CITY OF ALBUQUERQUE

Re: Maverik at I-25/Jefferson
5001 Jefferson NE Albuquerque, NM 87109
Traffic Circulation Layout
Engineer's/Architect's Stamp 3/12/2019 (F17D044C1)

The TCL submittal received 03-12-2019 is approved for Building Permit with. A copy of the stamped and signed plan will be needed for each of the building permit plans. Please keep the original to be used for certification of the site for final C.O. for Transportation.

| | | | SHEET # TCL 1 |

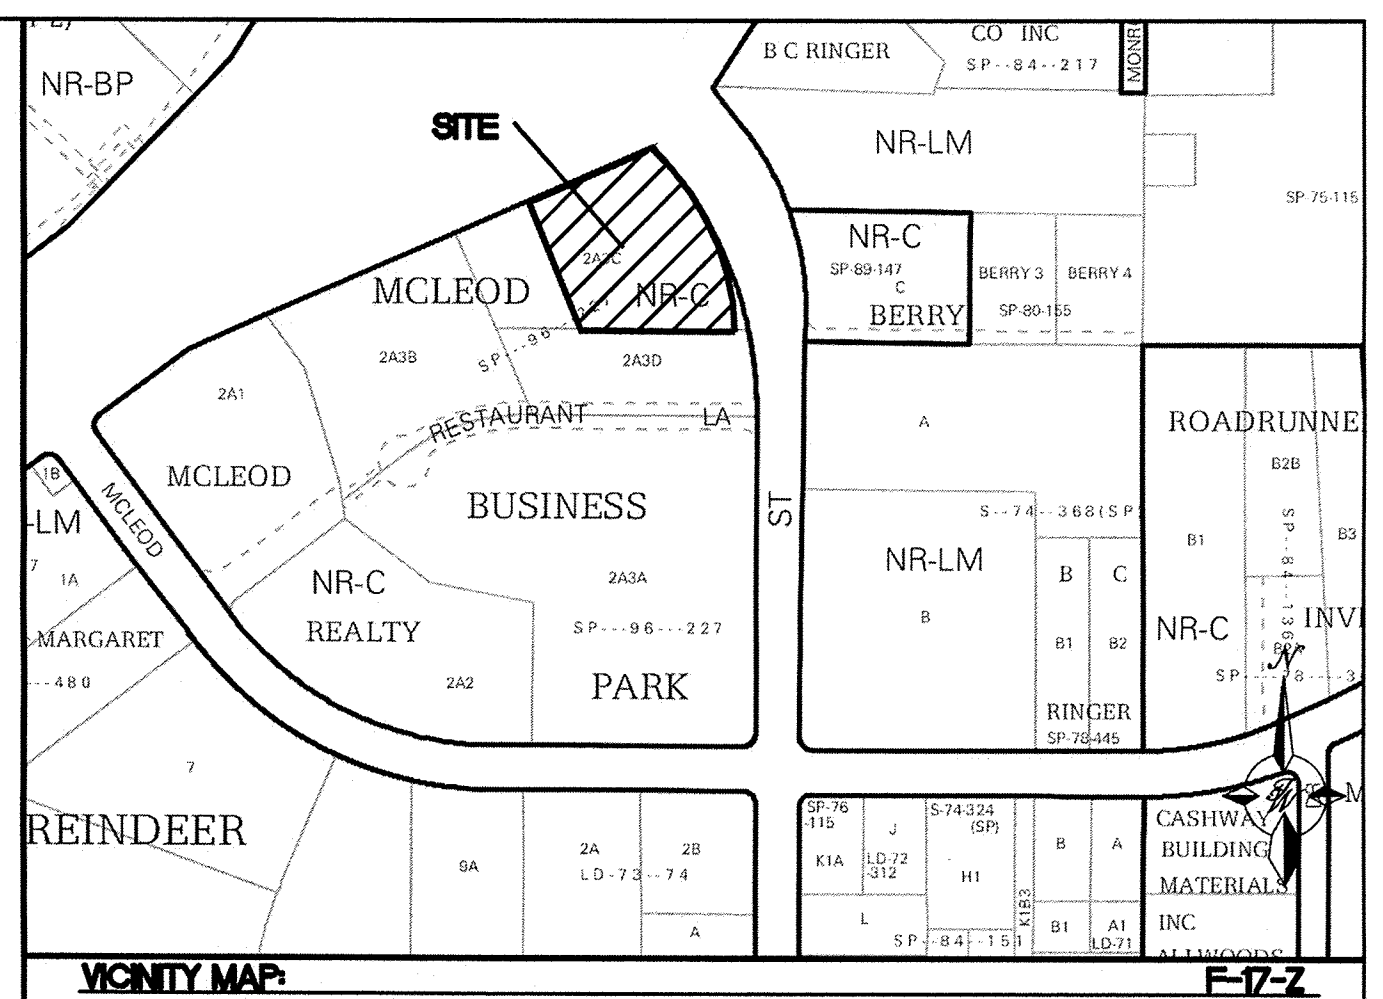
ALL WHEELCHAIR RAMPS LOCATED
WITHIN THE PUBLIC RIGHT OF WAY
MUST HAVE TRUNCATED DOMES.
